**RE: Objections to “Seigler Springs North” commercial cannabis cultivation, UP 21-17,
IS 21-18.**

Subject: Review of May 19, 2023, Hydrology Report and Drought Management Plan – UP 21-17, Seigler Springs North Cultivation Project

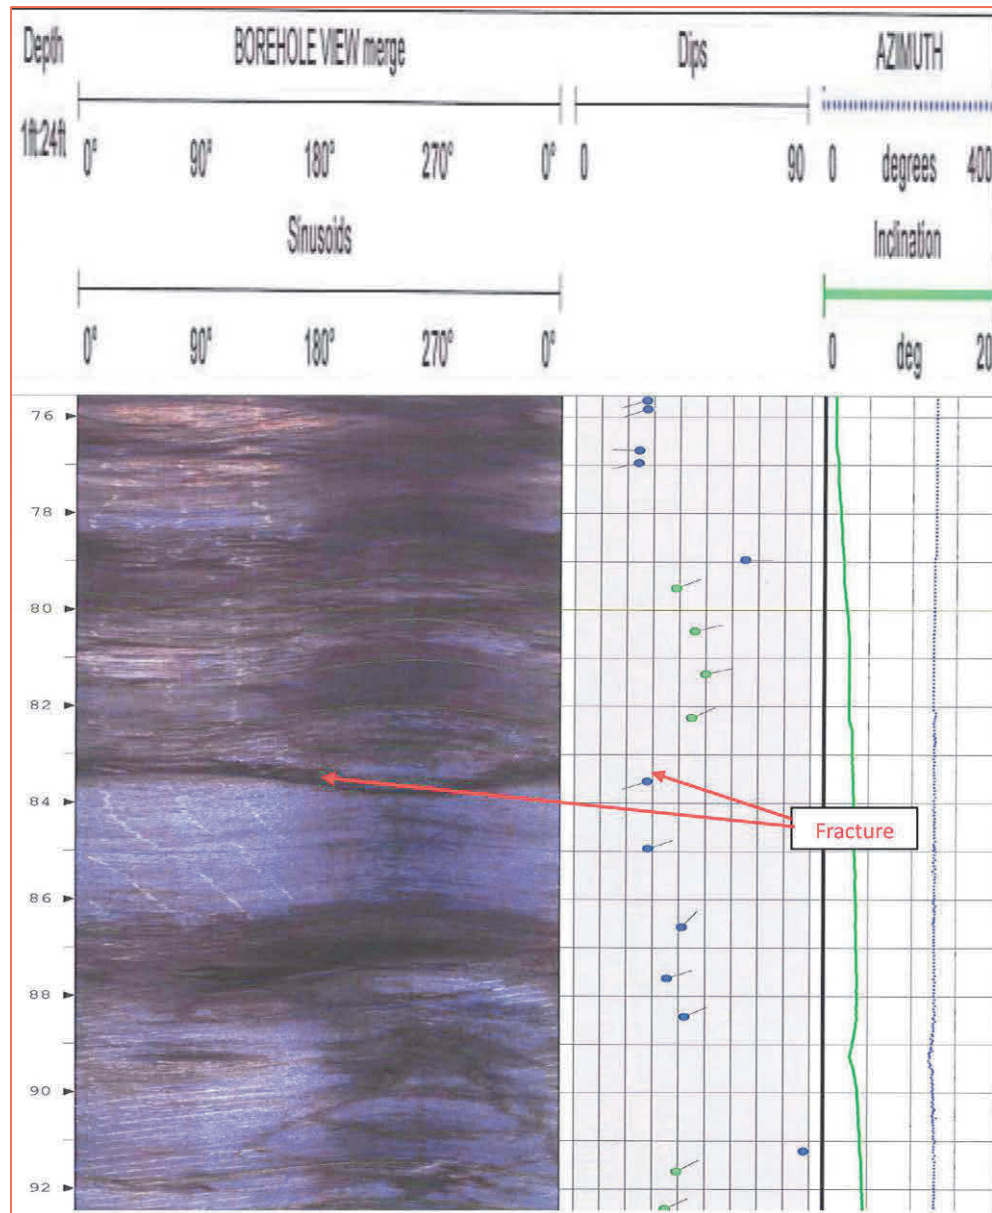
To assess the amount of fractures that contain water, a test hole should be completed, and an acoustic televiewer (to assess number and orientation of fractures) and heat pulse flow meter conducted to assess which fractures transmit water. An example of both these methods are shown in Figures 3 (acoustic/optical televiewer) and 4 (heat pulse televiewer). As seen in these figures, although many fractures may be present, only a small amount are producing water. At the site these measurements were taken near Quincy California, recognition of these features was critical in protecting a supply well for a small hotel.

Based on the information provided above, the actual groundwater storage within the aquifer beneath the proposed project is significantly less than reported and possibly orders of magnitude lower. If this information is not assessed, significant impacts could occur through the drying up of fractures as is discussed further in Comments 4 and 5.

Figure 4. Example of heat pulse flow meter showing which fractures produce water.

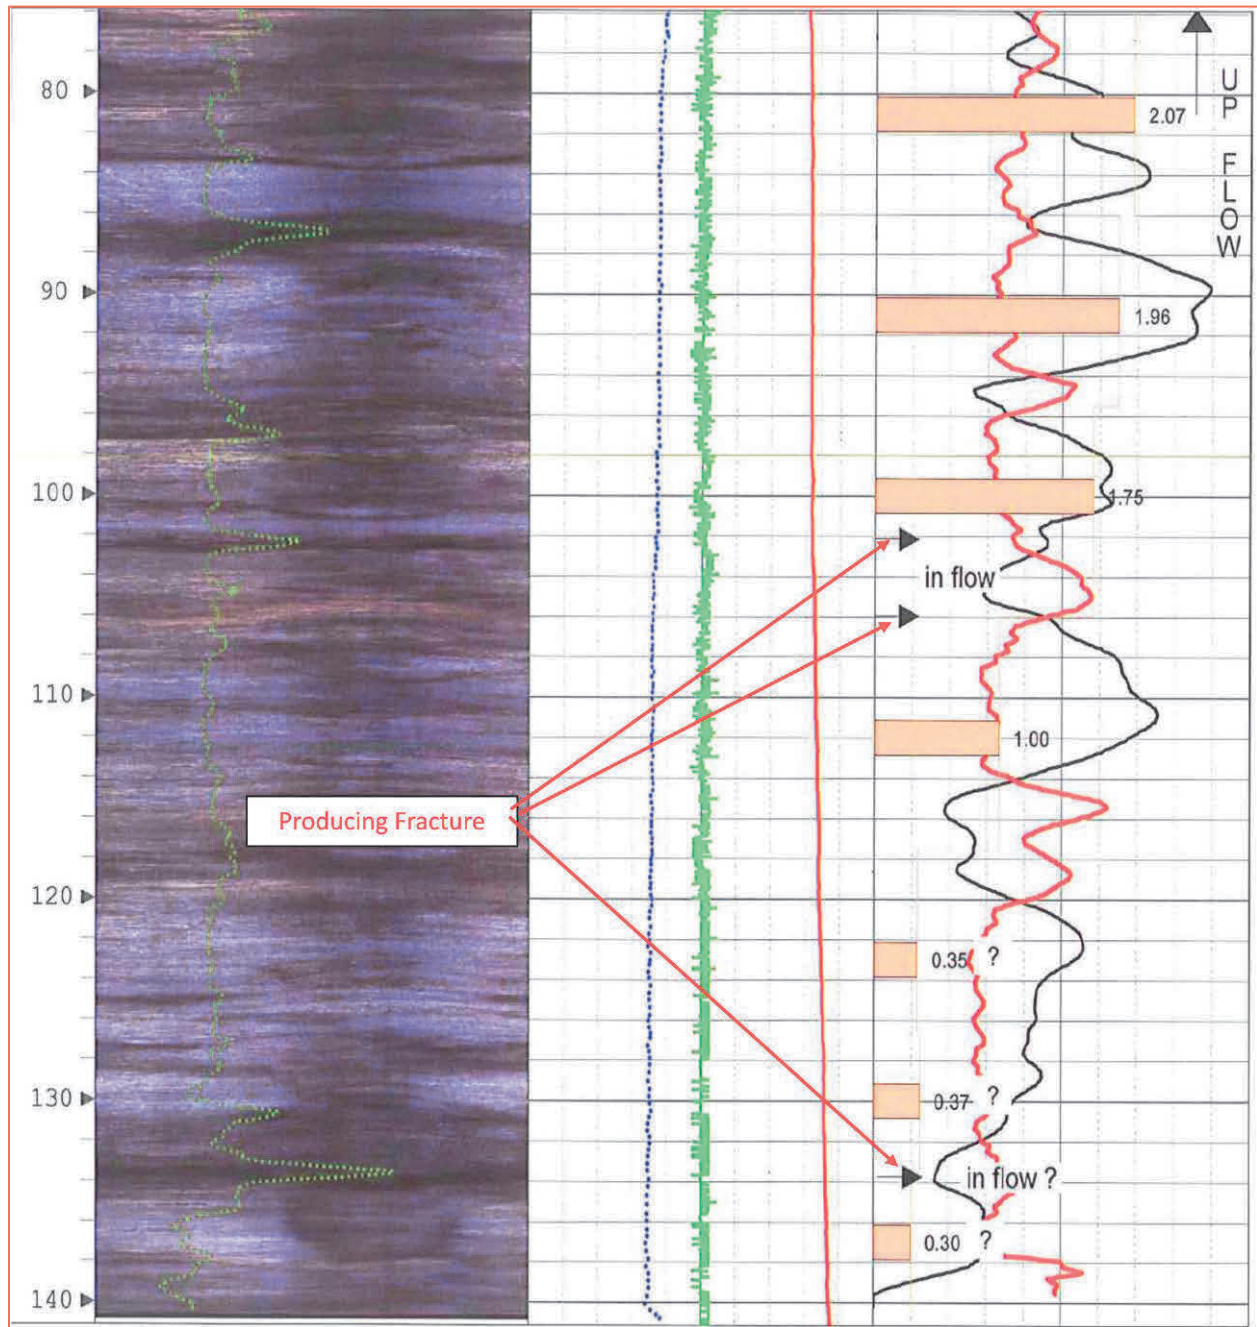
To provide an accurate assessment of cumulative impacts to the surrounding area, first the orientation and dip of the producing fractures must be known. This information can be obtained by use of the optical televiwer and heat pulse flow meter discussed for Comment 3. For example, if the producing fractures trend towards the northeast or southeast, then pumping on the proposed project well could have significant impact to the existing wells at the Mountain of Attention property.

Figure 4-1 – Regional context and primary evacuation corridor.

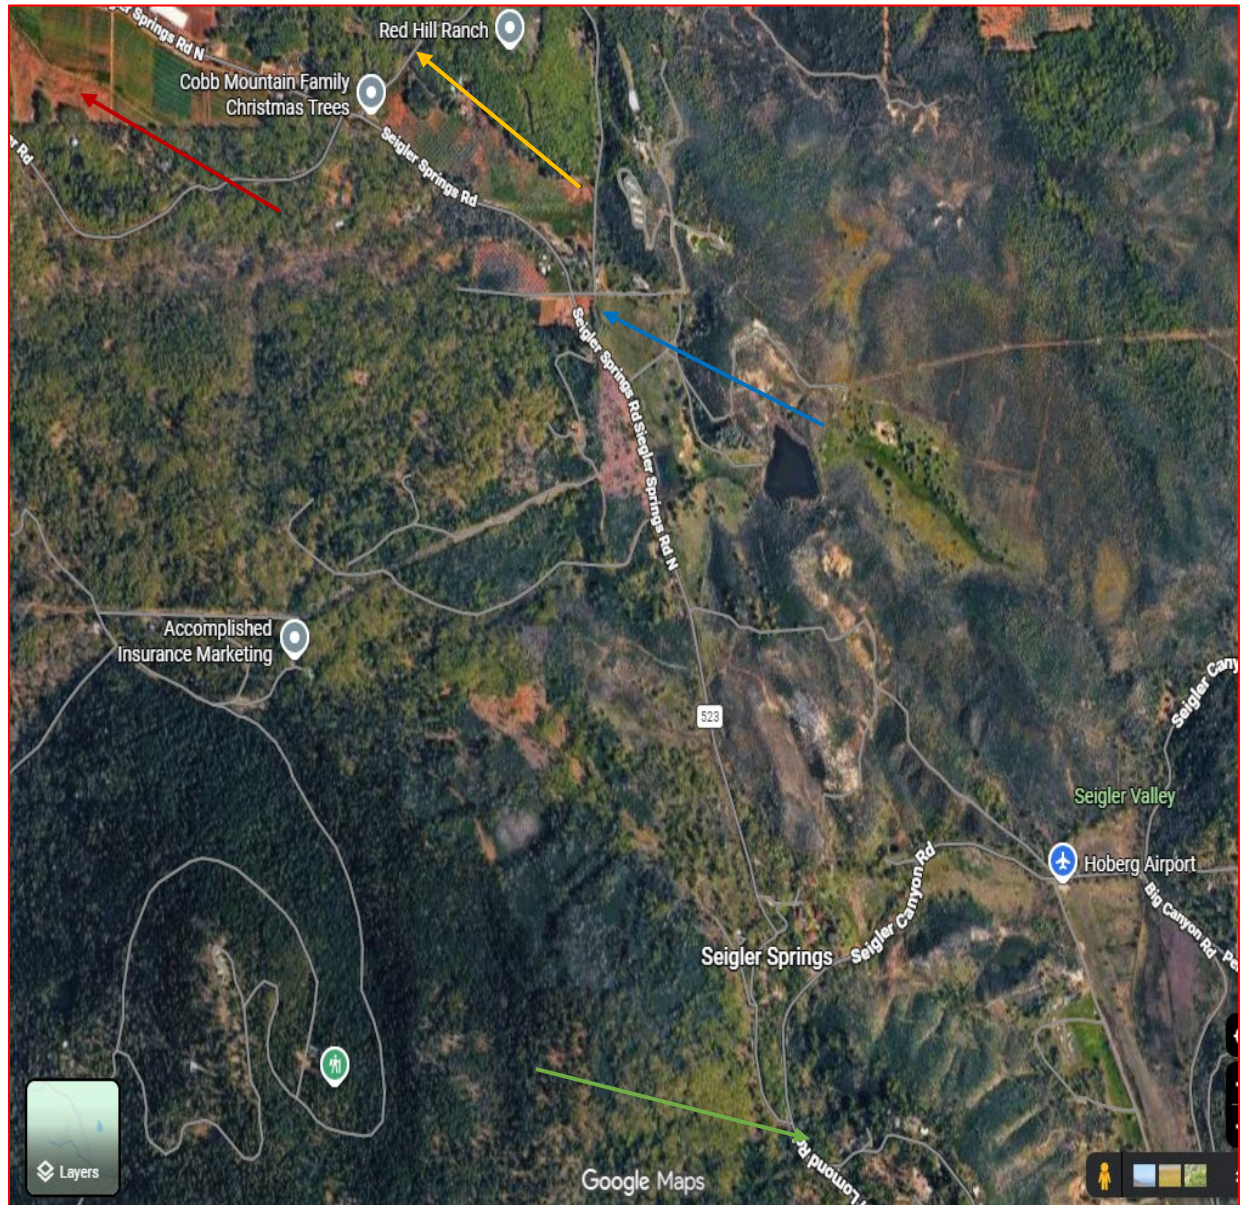
Unlike urban transportation systems that provide multiple evacuation options, this area depends upon a limited rural road network. During a wildfire emergency, these roads must simultaneously accommodate evacuating residents, project employees, visitors, retreatants, emergency responders, utility crews, and mutual aid resources.

Figure 6-3 – 90-degree turn affecting opposing traffic. Major choke point

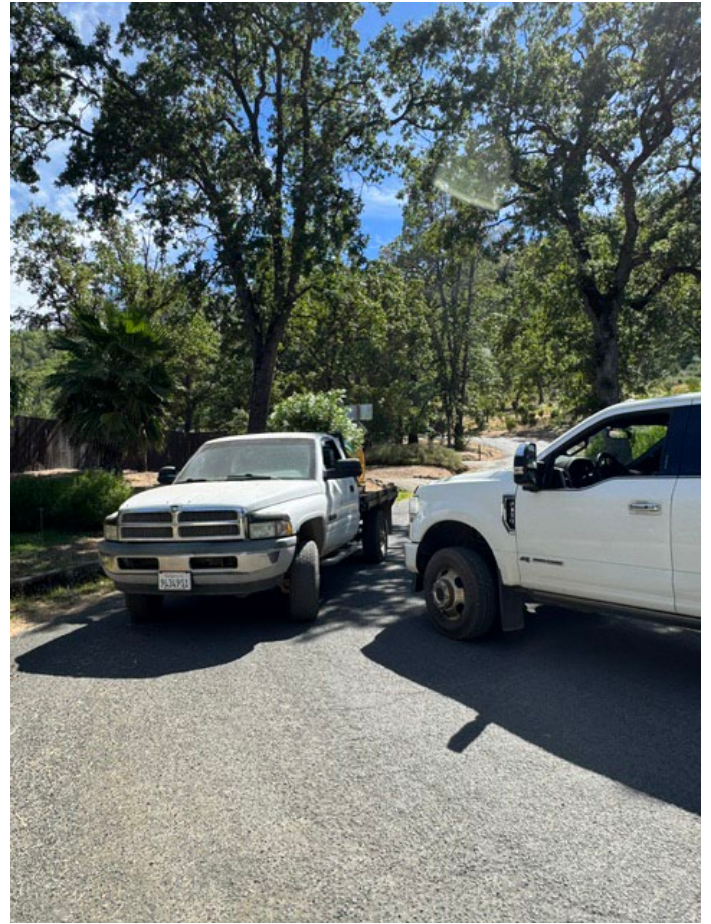
Limited sight distance occurs at several locations along Seigler Springs North Road, reducing the ability of opposing traffic to observe approaching vehicles during emergency operations.

Representative 90-degree turn illustrating roadway geometry and vehicle maneuvering characteristics.
